## Metro Inner Development Assessment Panel Agenda

- 3.1 Lot 418 (No. 91) & Lot 419 (No. 93) Canning Highway, Lot 81 (No. 70) St Peters Road & Lot 423 King Street, East Fremantle - Nine Grouped Dwellings – DAP/26/03098

**Part B – Item 3.1 – Lot 418 (No. 91) & Lot 419 (No. 93) Canning Highway, Lot 81 (No. 70) St Peters Road & Lot 423 King Street, East Fremantle – Nine Grouped Dwellings**

**Form 1 – Responsible Authority Report**  
(Regulation 12)

Figure 1 - Building Envelope Diagram – West Elevation (extract from applicant’s development application)

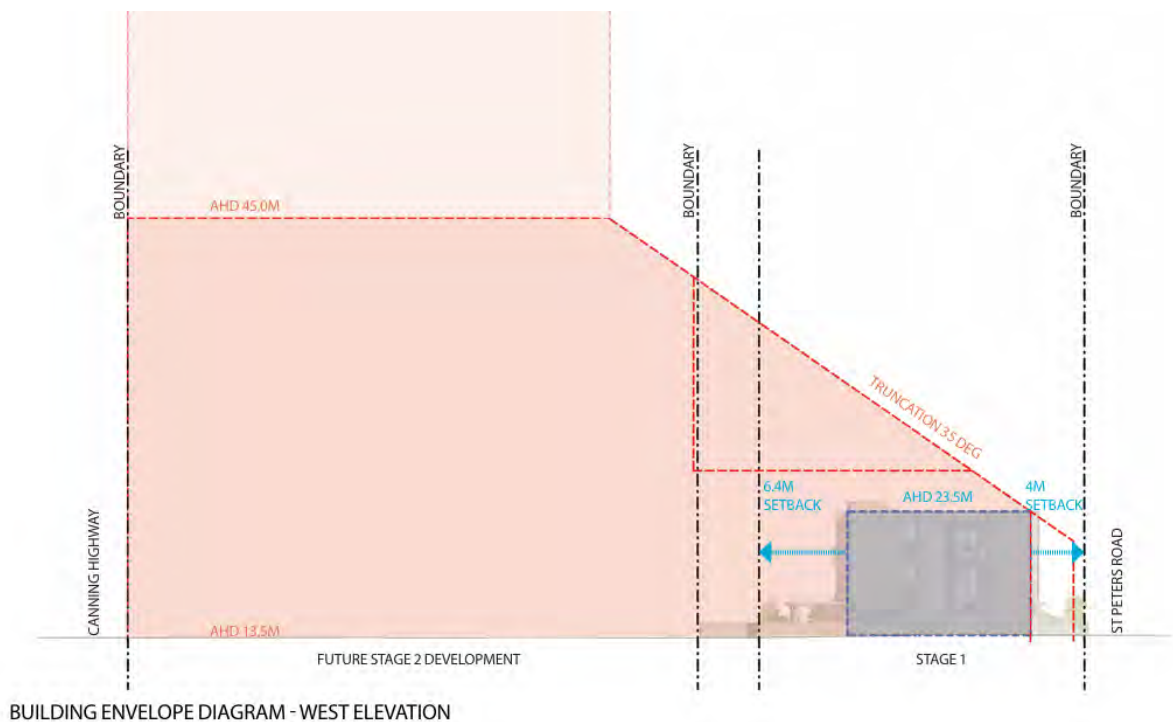
The provisions of Cl. 5.10.1 – ASR1 require that development must stay within the building envelope defined in Figures 1 and 2, with limited projections allowed for integrated amenities and screened services that remain set back within a 45-degree height plane and street setback, and which complement the building’s design.

While the Town considers the “*metal canopy*” can be considered compliant under ASR1 provisions, it does not accept the “*vertical architectural element*” or the boundary fence/wall as exempt, meaning it considers both building elements exceed the building envelope of Figures 1 and 2 (refer to Attachment 10) in respect to non-compliance with the building height and setback as illustrated below in an extract from the applicant’s development plans and elevations.

While the Town was not the final author of Amendment 14, nor of the specific ASR1 provisions in respect to building height, it initially endorsed other building height and setback provisions for Schedule 13 which were intended to prevent any encroachment into the St Peters Road setback area beyond 4m and endorsed a height limit of two storeys on St Peters Road.

DRAWING No DA0-03

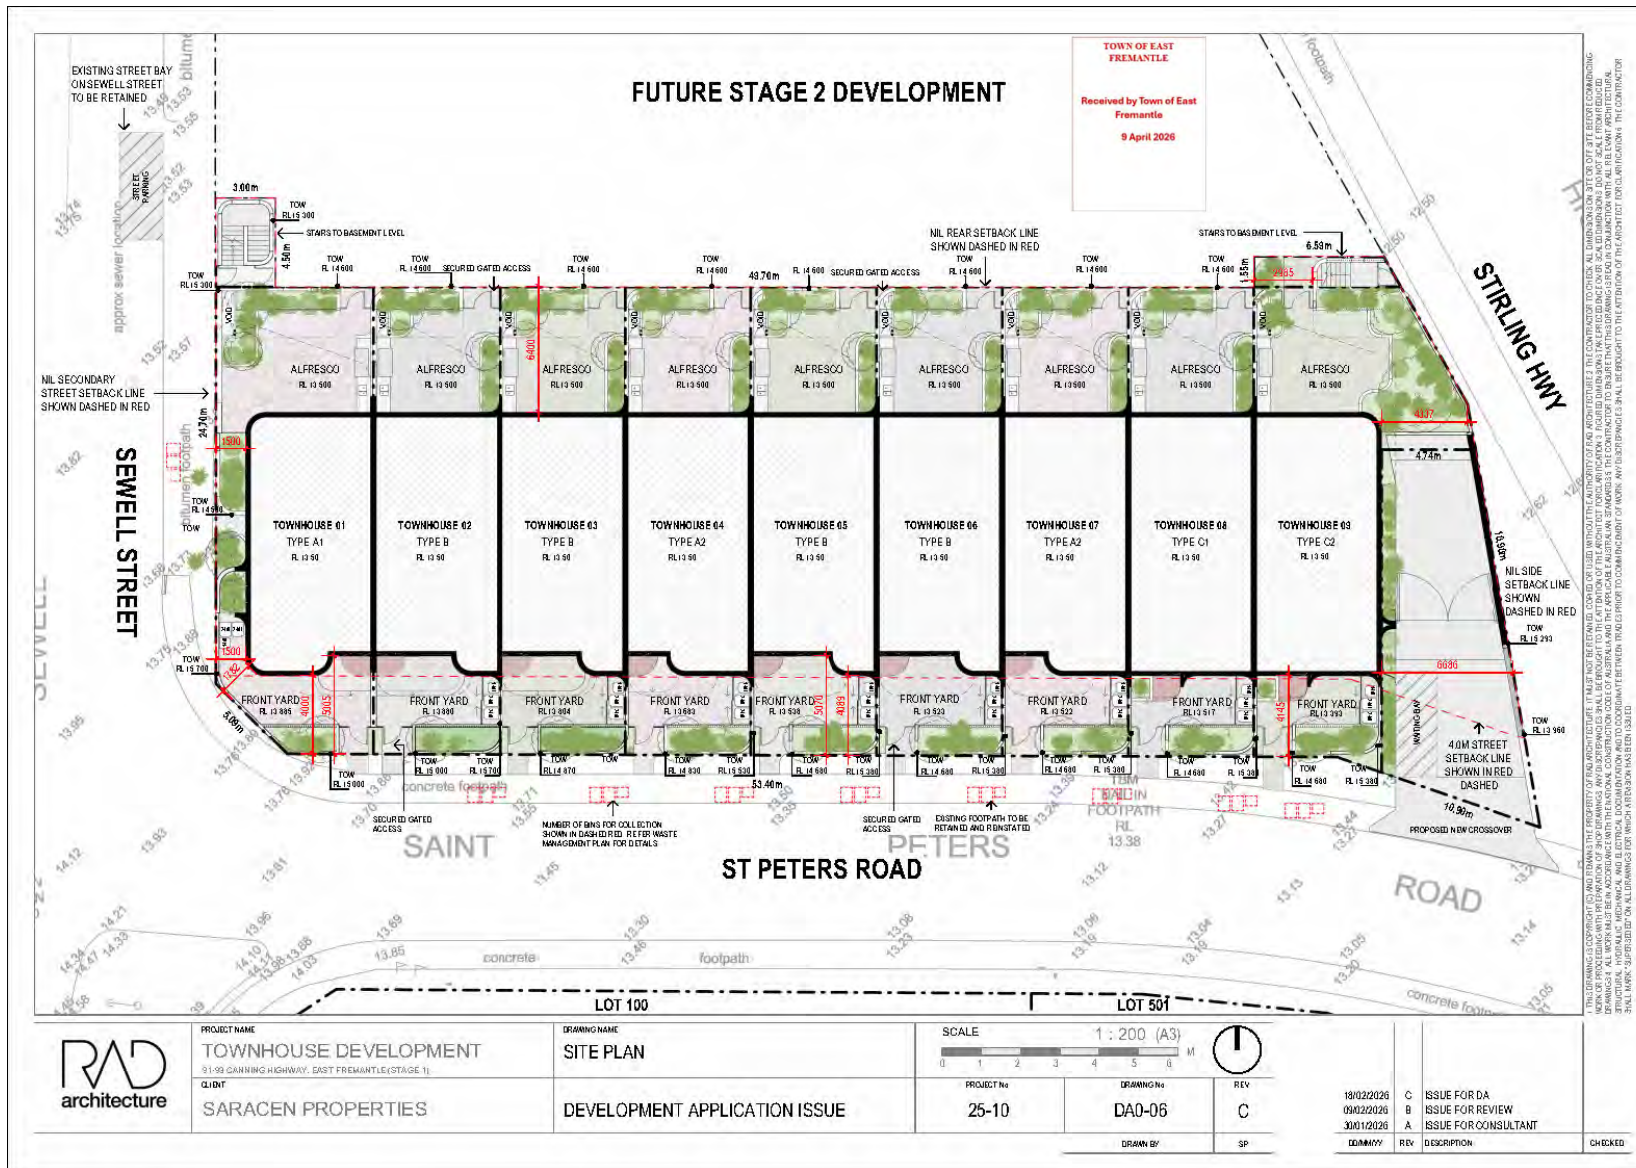
The applicant's site survey shows three street trees on Sewell Street and the demolition plan indicates they are proposed to be removed. However, these trees are located within the road reserve verge area and their removal is subject to approval of the Town under the Town of East Fremantle Public Places and Local Government Property Local Law 2016. The DAP does not have any jurisdiction in this regard. The Town does not support their removal. This position reflects the Town's commitment to preserving tree canopy within the public realm and avoiding further loss of established verge vegetation. For the avoidance of any doubt the retention of these trees is a recommended condition of approval.

Furthermore, it is the applicant's intention to remove all existing vegetation with the exception of the large Ficus tree in the north-east corner of the site. These trees are identified in Attachment 3 – Demolition Plan Drawing DA0-03. The Town's Operation's section has made the following comments in relation to the extent of tree removal, given some trees do not require removal to facilitate the development proposal outlined as Stage 1, the subject of this application.

Conditions of development approval are therefore considered necessary to ensure that the trees located outside the Stage 1 development proposal area, including trees within the road reserve are retained. These trees (as indicated in Attachment 8) should be retained and indicated as such on the building permit application plans

and/or a separate tree retention plan to be approved by the Town prior to the building permit application being submitted.
